NSTX TF Bundle Failure

Mike Williams
September 13, 2011

The NSTX Toroidal Field (TF) Bundle failed on July 20, 2011:

Old

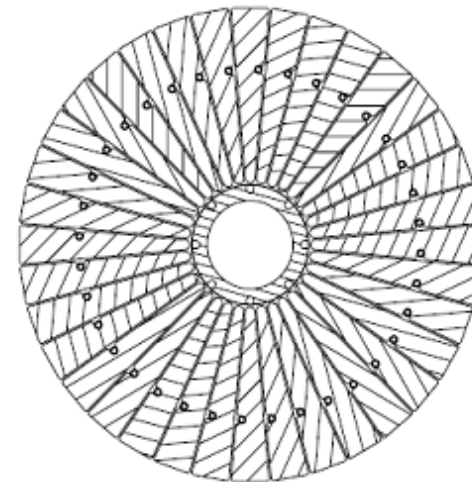
- Single-layer versus double layer design
 - Reduced voltage stress between conductors (30 volts)
 - Terminal voltage (1 kV) across quadrant segments where there is increased insulation
- VPI versus B-Stage glass resin system
 - More homogenous insulation system without voids
- Bundle manufacturing process will be greatly improved to address residual solder flux
- A spare TF/OH Bundle will be fabricated
- Increased maintenance
